## ORIGINATION FORM

### Proposed Revisions to a Standard Plans Index (Please provide all information — Incomplete forms will be returned)

Index Number: 649-020

Index Title: Steel CCTV Pole

**DETAIL "E"**

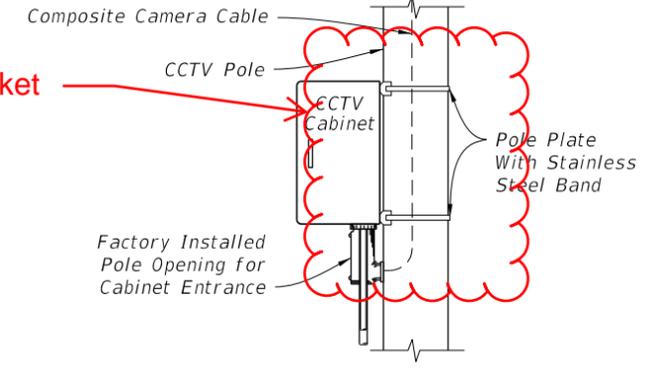
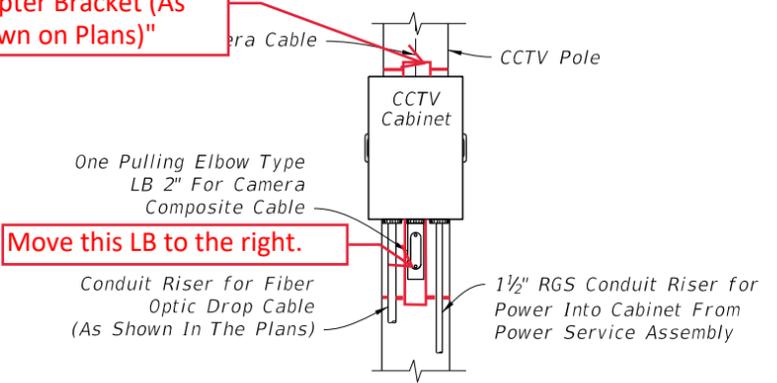
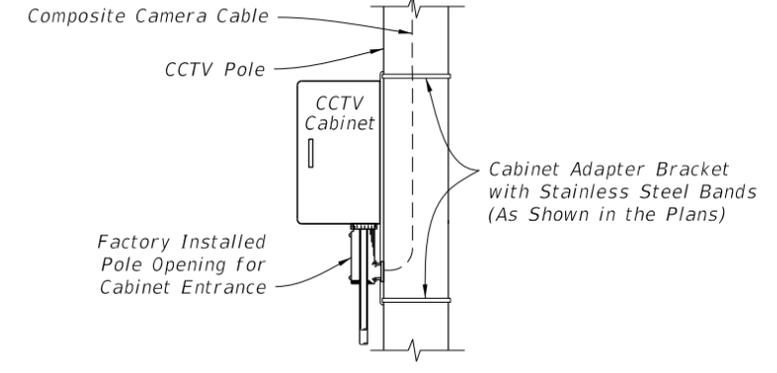
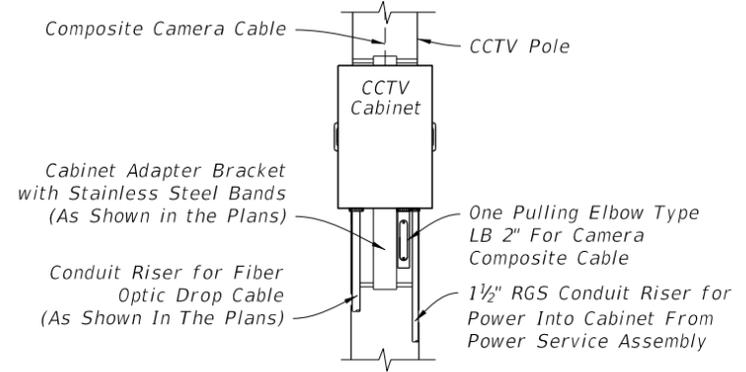
Sheet 6: Deleted the "Pole Plate With Stainless Steel Band" and Added new "Cabinet Adapter Bracket" shown in DETAIL "E" and the POLE MOUNTED CABINET detail.

Add note: "Cabinet Adapter Bracket (As Shown on Plans)"

Move this LB to the right.

"676-2.5.9 Adapter Bracket: If shown in the plans, provide an adapter bracket for pole mounted cabinets that is slotted or otherwise designed to allow banding straps to be installed to avoid pole handholes."

POLE MOUNTED CABINET

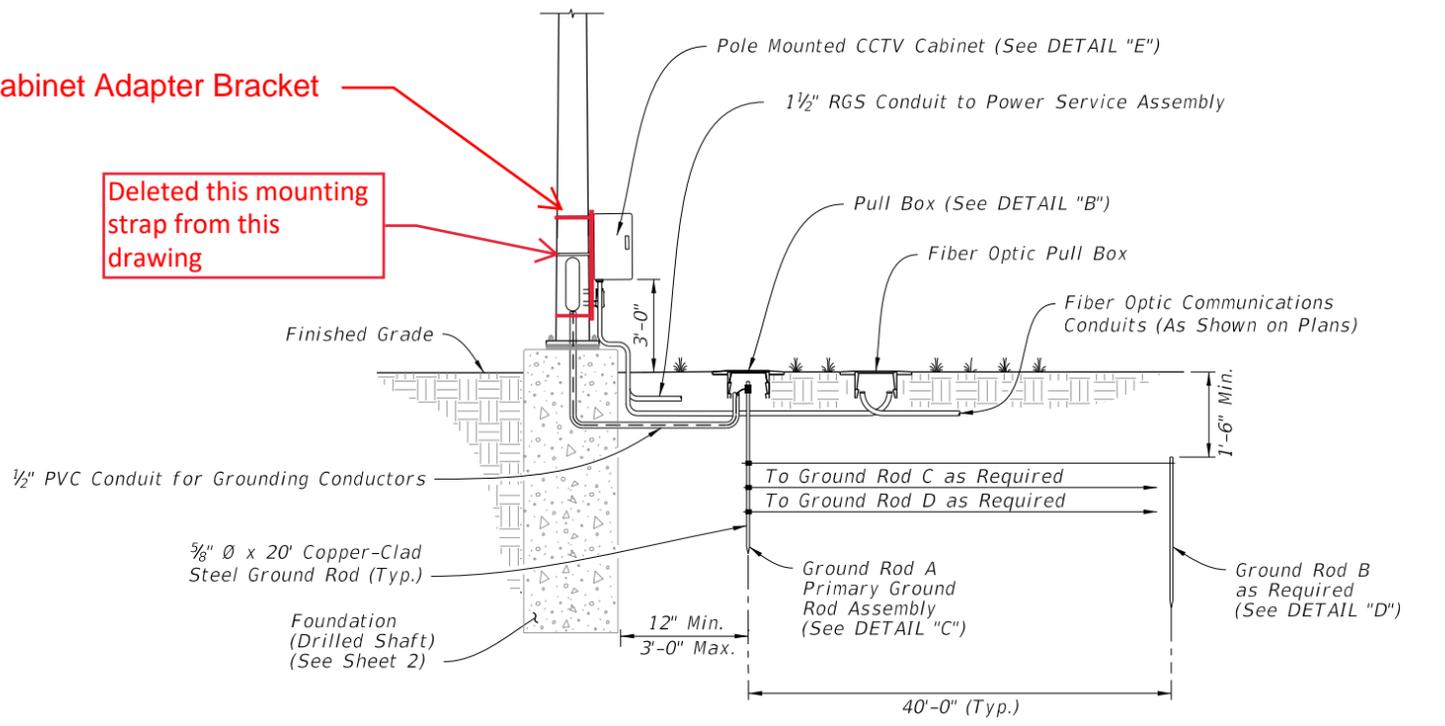
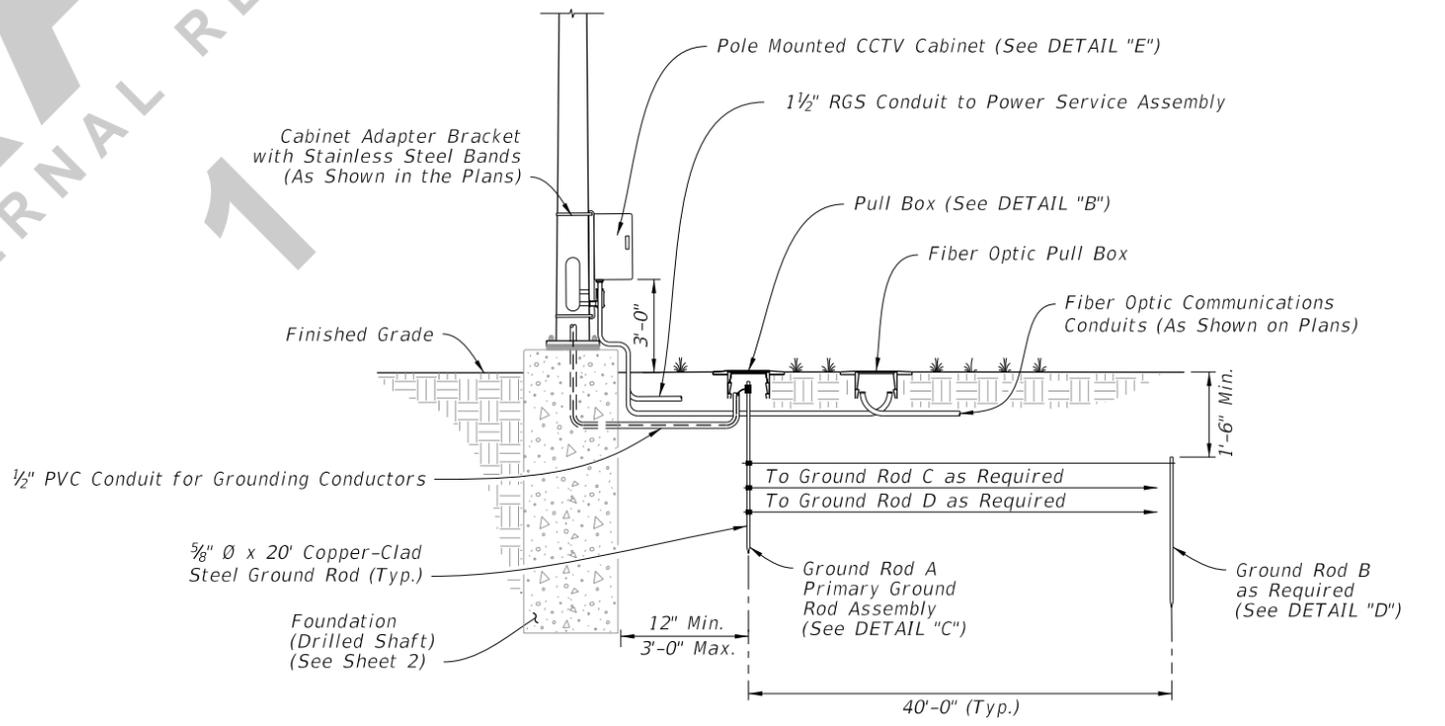
The CCTV pole hand hole had been vertically elongated, however, the CCTV cabinet bracket locations remained the same. As a result, when mounted, the CCTV cabinet mounting straps partially cover the CCTV pole hand holes.

Added: Cabinet Adapter Bracket

Deleted this mounting strap from this drawing
